Former Randall's Department Store, Uxbridge

Fire Station Structural Assessment

Project No. 113780

April 2018

FIRE STATION FIRST FLOOR

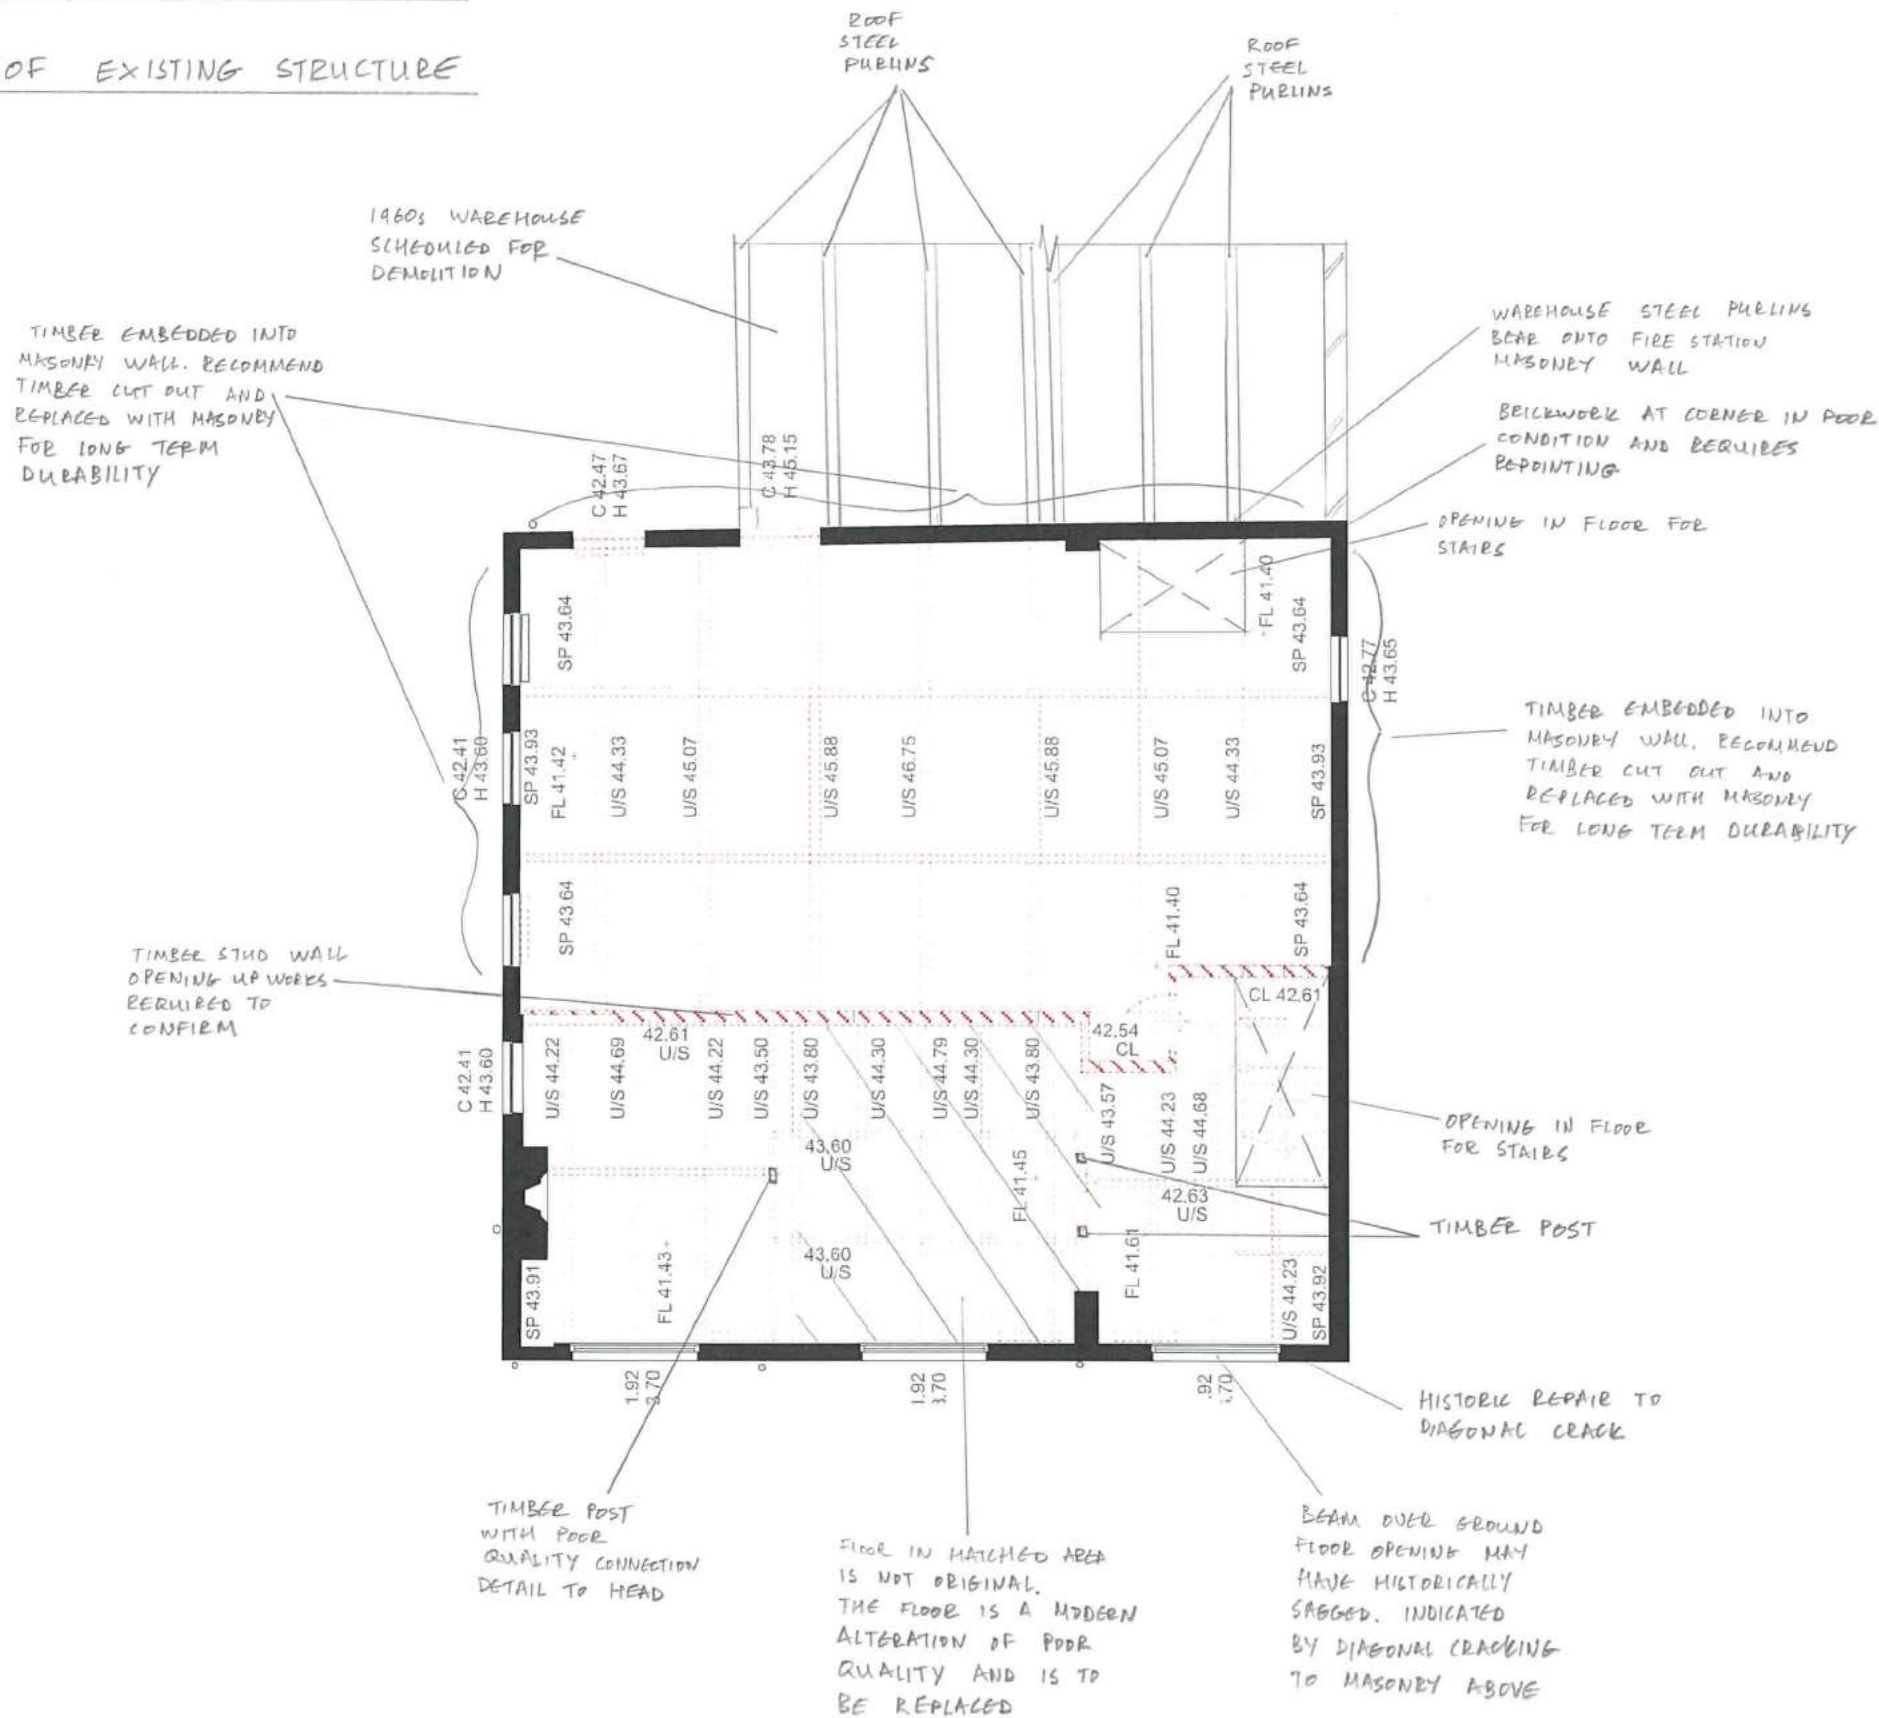
1960s WAREHOUSE WITH
MASONRY WALLS AND
STEEL FRAMED ROOF
WAREHOUSE SCHEDULED
FOR DEMOLITION

MASONRY WALL TO BE
REDUCED IN HEIGHT
FOLLOWING DEMOLITION OF
WAREHOUSE

MASONRY AROUND
FULL PERIMETER OF
BUILDING REQUIRES
REPOINTING

MASONRY WALL
SUPPORTS STRUCTURE
ABOVE AND
PROVIDES HORIZONTAL
STABILITY

EVIDENCE OF HISTORICALLY
INFILLED OPENING

WALL IN POOR CONDITION
AND HAS BOWED

HIGH LEVEL
GROUND FLOOR
TIE RODS
FIXED ACROSS
WIDTH OF
BUILDING

TIMBER POSTS ARE A
MODERN ALTERATION AND
ARE OF POOR QUALITY

SKELLS MISSING AT CORNER

HISTORIC ALTERATIONS PRESENT TO
GROUND FLOOR FRONT ELEVATION

MARKUP OF EXISTING STRUCTURE

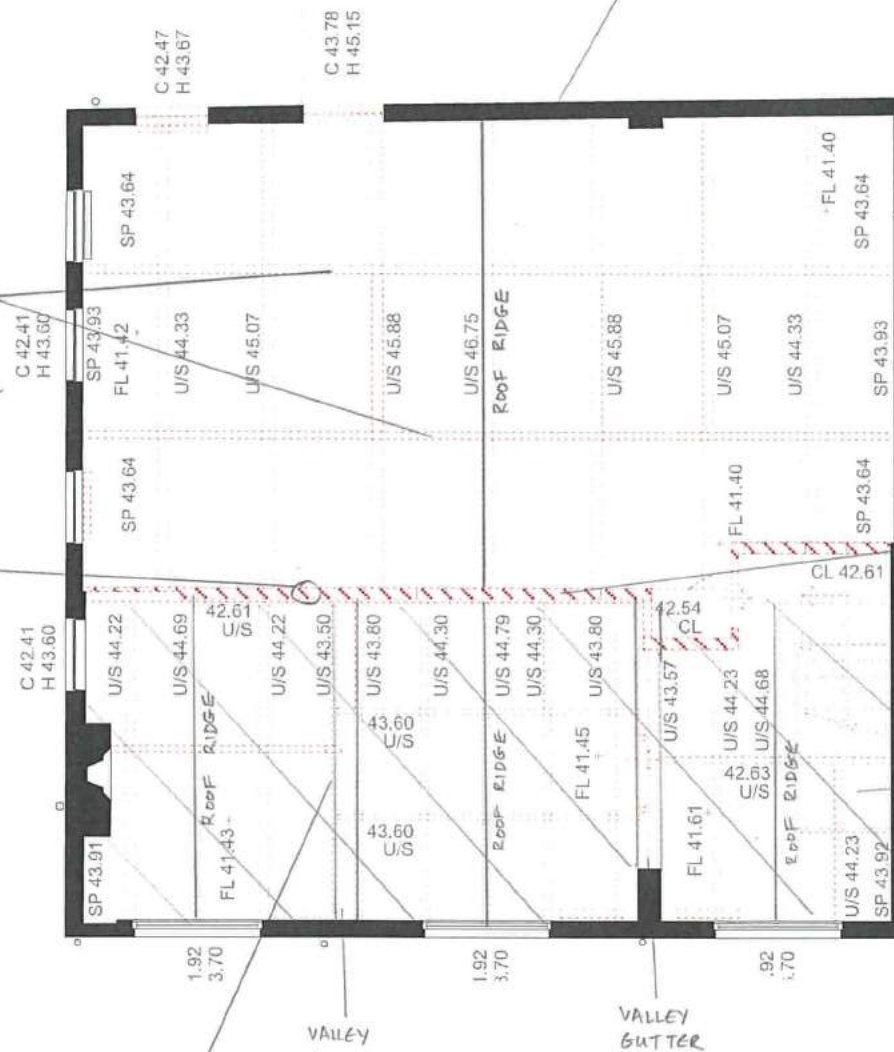
HOLE PRESENT THROUGH
ROOF GABLE. THE HOLE
WILL HAVE LET WATER
INTO THE STRUCTURE,
POSSIBLY CAUSING ROT
TO OCCUR.

TIMBER
ROOF STRUCTURE IN HATCHED
AREA IS IN POOR CONDITION AND
HAS BEEN SUBJECT TO A NUMBER
OF MODERN ALTERATIONS OF
POOR QUALITY. ROOF STRUCTURE
TO BE REPLACED.

RAIL TRACK
FORMS VALLEY
BEAM, AND
SUPPORTS
TIMBER ROOF
TRUSSES

DETAIL 1
STEEL TO TIMBER CONNECTION

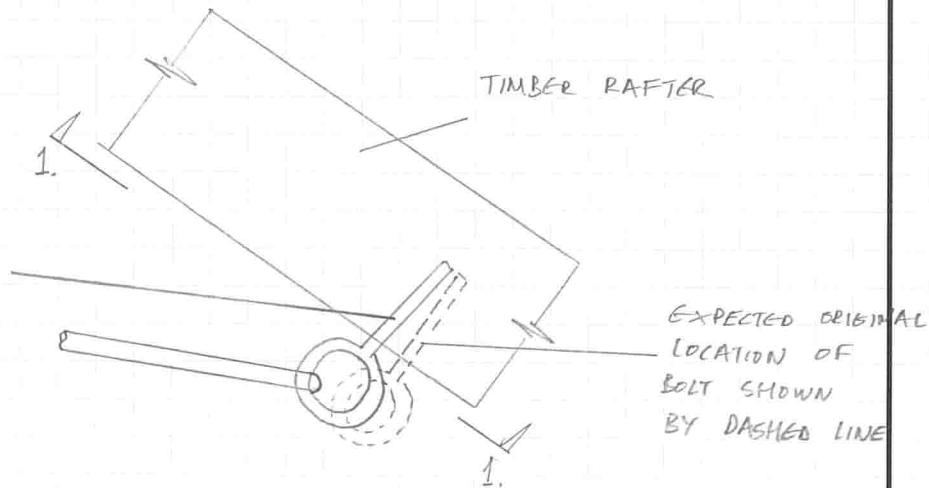
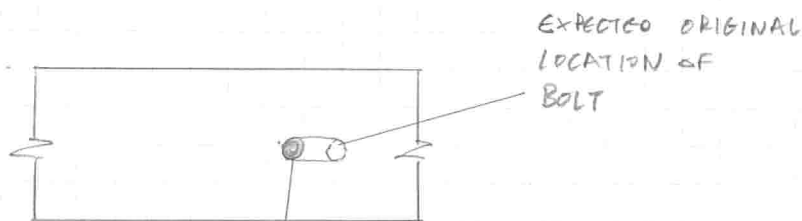
TENSION IN METAL
TIE LOOKS TO
HAVE CAUSED
MOVEMENT OF
BOLT

Internal view at south-east corner of building
at first floor level

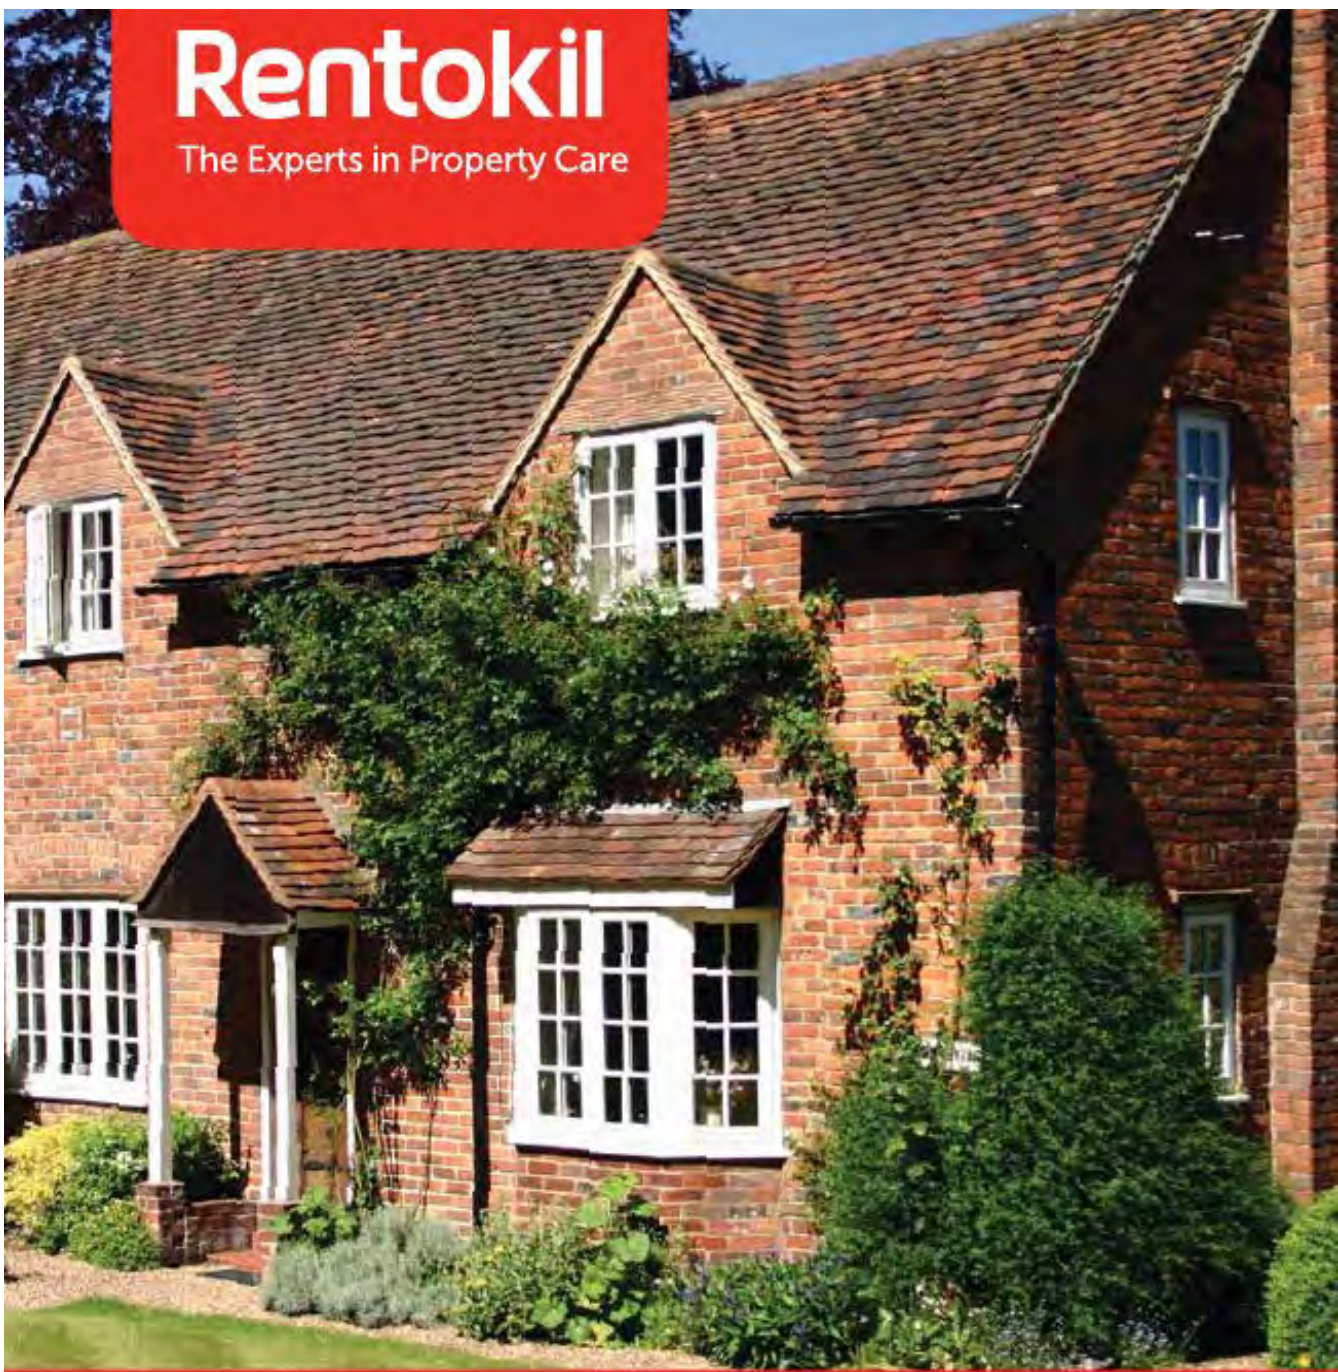
Cracks to be repaired.

Existing signage board to be removed to identify if masonry cracking present. Cracks to be repaired.

Cracks to be repaired.
